PRIVATE WATER DISTRIBUTION SYSTEM

to serve
Prairie Pointe at Cornerstone
2nd Addition
CITY OF ANDOVER, KANSAS

AS BUILT PLANS
Client: City of Wichita
Contractor: McCullough Excavation
Superintendent: Rob Grey
Inspection Firm: Garver
Inspector: Eric Strecker
PDF BY: ELS, 08/12/2020

RECORD DRAWINGS
CONTRACTOR: McCULLOUGH EXCAVATION
INSPECTOR: ERIC STRECKER (GARVER)
PDF BY: ELS 8/11/2020

WATER LINE 2
(1 of 2)

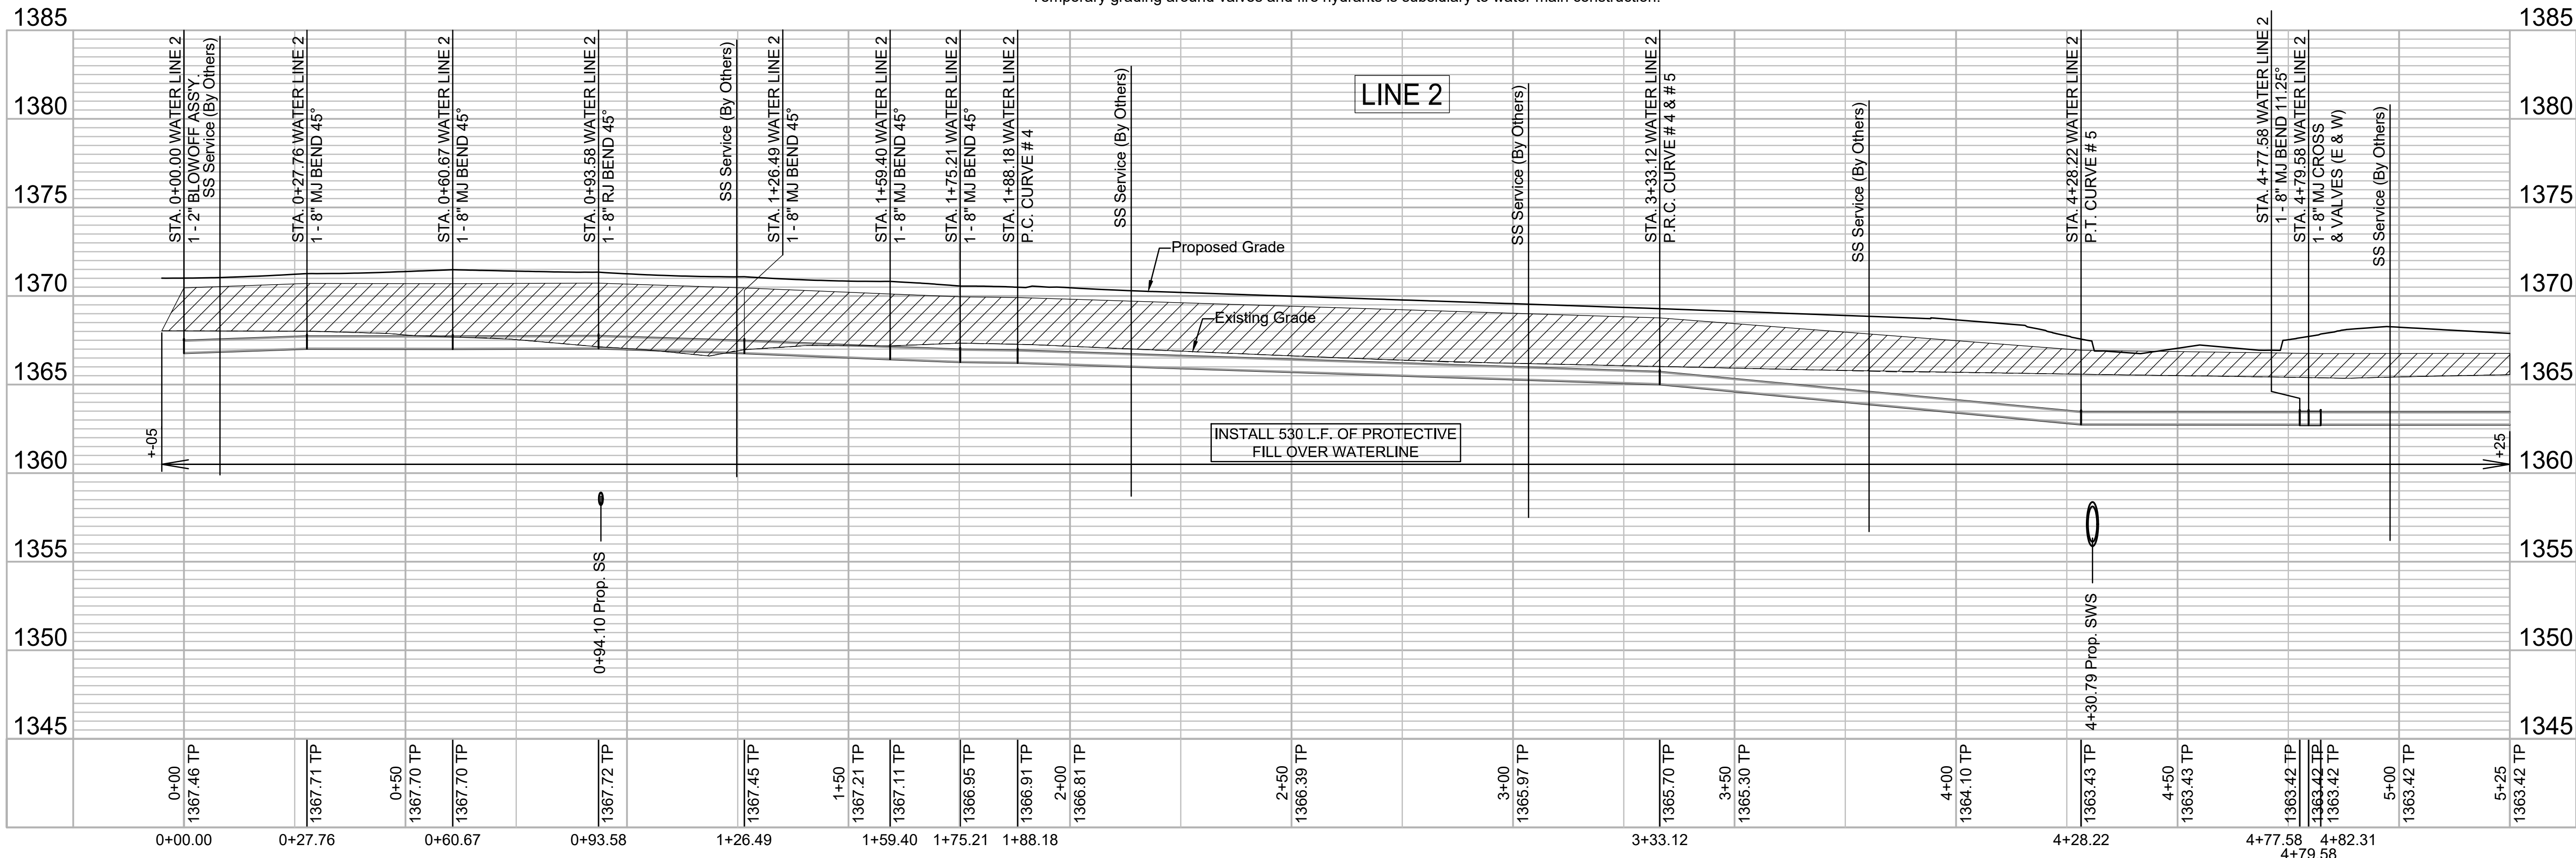
8" MJ DI 45° Bend
SIP C153 DI350
285.16' W. & 34.55' N. of Int. of
Cobblestone St. & Millstone Ct.

15.81 L.F. 8" PVC
N 20807.38 E 20238.16
STA. 1+75.21, WATER LINE 2 =
STA. 1+33.73 MILLSTONE CT., 21.00' LT
1-8" MJ BEND 45°

8" MJ DI 45° Bend
SIP C153 DI350
277.02' W. & 21.0' N.
of Int. of Cobblestone
St. & Millstone Ct.

8" MJ DI 11.25° Bend
SIP C153 DI350
18.59' E. & 20.0' N. of Int. of
Cobblestone St. & Millstone Ct.

8" MJ DI 45° Bend
SIP C153 DI350
317.09' W. & 42.53'
N. of Int. of
Cobblestone St. &
Millstone Ct.

N 20795.28 E 20170.80
STA. 0+93.58, WATER LINE 2 =
STA. 0+65.44 MILLSTONE CT., 25.59' LT
1-8" MJ BEND 45° (RESTRAINED JOINT)

8" MJ DI 45° Bend
SIP C153 DI350
345.30' W. & 25.59'
N. of Int. of
Cobblestone St. &
Millstone Ct.

N 20762.37 E 20170.80
STA. 0+60.67, WATER LINE 2 =
STA. 0+57.47 MILLSTONE CT., 6.34' RT
1-8" MJ BEND 45°

8" MJ DI 45° Bend
SIP C153 DI350
353.28' W. & 6.34' S. of Int. of
Cobblestone St. & Millstone Ct.

N 20739.10 E 20194.07
STA. 0+27.76, WATER LINE 2 =
STA. 0+74.41 MILLSTONE CT., 34.55' RT
1-8" MJ BEND 45°

8" MJ DI 45° Bend
SIP C153 DI350
336.30' W. & 34.54' S. of
Int. of Cobblestone St. &
Millstone Ct.

309.41' W. & 41.28' S. of Int. of
Cobblestone St. & Millstone Ct.

WATER LINE 2
 (2 of 2)

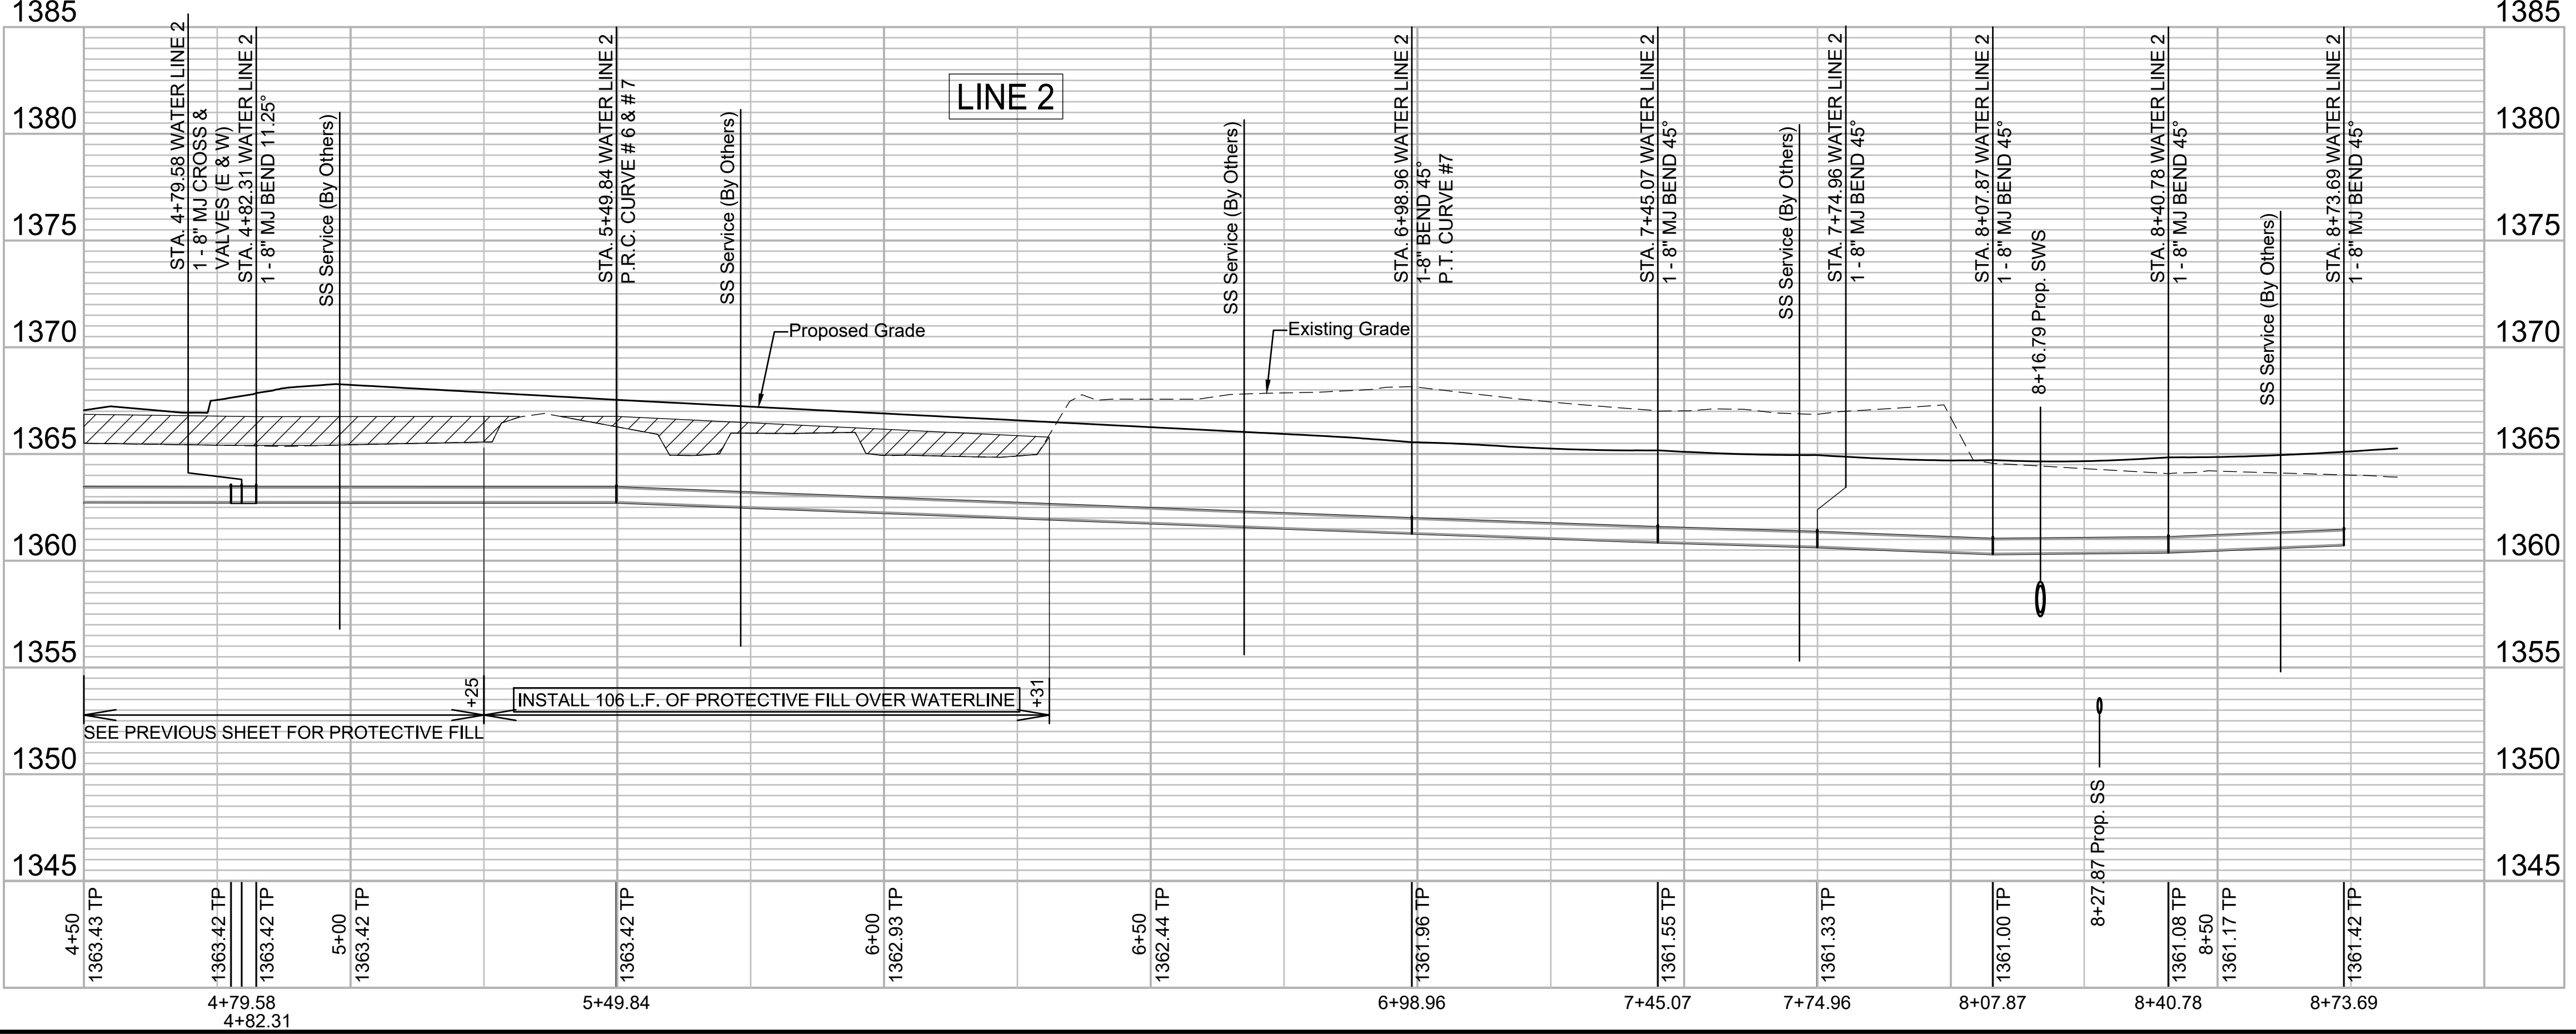
294.29' E. & 42.99' S. of Int. of Cobblestone St. & Millstone Ct.
 N 20725.12 E 20809.71
 STA. 8+73.69, WATER LINE 2 = STA. 6+94.04 COBBLESTONE CT., 42.99' RT
 1 - 2" BLOWOFF ASS'Y.
 VALVE BOX ELEV. 1365.10 1365.06

EROSION CONTROL PLAN

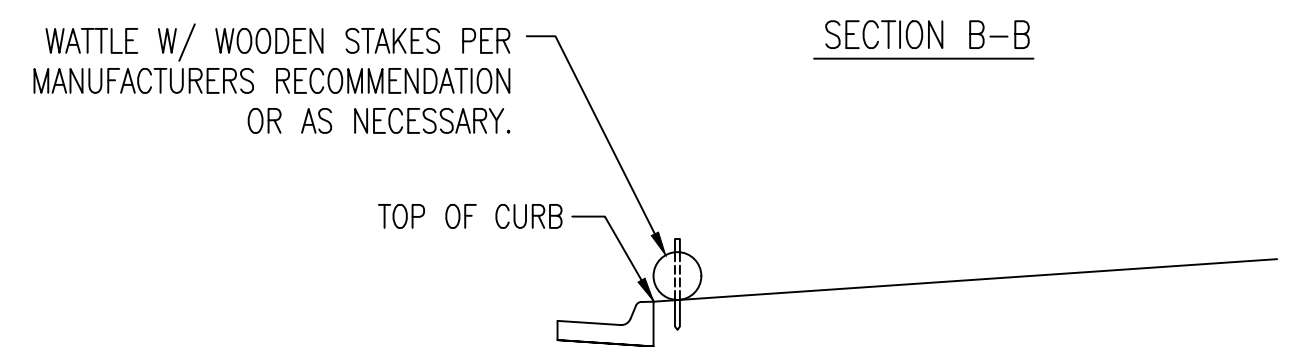
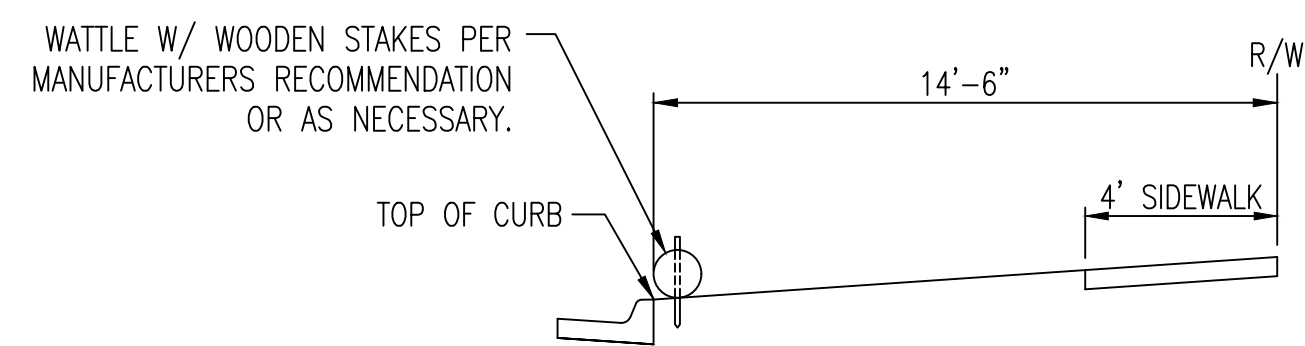
CONTRACTOR TO ENSURE INLET PROTECTION DOES NOT CREATE BACKWATER & SHALL PROTECT HOMES FROM FLOODING & STANDING WATER. INLET PROTECTION MAY NOT BE NECESSARY AT THE TIME OF CONSTRUCTION FOR THESE TWO (2) INLETS.

Area Inlet protection not installed due to established sod around inlet top

Curb Inlet Protection #1 Installed 6-30-20 by McCullough Excavation Filter Sock & 2x4 board

Curb Inlet Protection #2 Installed 6-30-20 by McCullough Excavation Filter Sock & 2x4 board

Area Inlet Protection #3 Installed 7-7-20 by McCullough Excavation Silt Fence Barrier

Area Inlet Protection #4 Installed 7-7-20 by McCullough Excavation Silt Fence Barrier

Perimeter Protection #5 Installed 7-7-20 by Seeders Silt Fence Barrier

Driveway Inlet Protection #10 Installed 8-5-20 by McCullough Excavation Silt Fence Barrier & Dirt Berm

Curb Inlet Protection #12 Installed 8-5-20 by McCullough Excavation Silt Fence Barrier

Curb Inlet Protection #11 Installed 8-5-20 by McCullough Excavation Silt Fence Barrier

Area Inlet Protection #7 Installed 8-5-20 by McCullough Excavation Silt Fence Barrier & Dirt Berm

Area Inlet Protection #8 Installed 8-5-20 by McCullough Excavation Silt Fence Barrier & Dirt Berm

Perimeter Protection #6 Installed 7-7-20 by Seeders Silt Fence Barrier

Area Inlet Protection #14 Installed 8-5-20 by McCullough Excavation Silt Fence Barrier & Dirt Berm

Area Inlet Protection #13 Installed 8-5-20 by McCullough Excavation Silt Fence Barrier & Dirt Berm

Area Inlet Protection #9 Installed 8-5-20 by McCullough Excavation Silt Fence Barrier & Dirt Berm

Silt Fence adjusted installation alignment
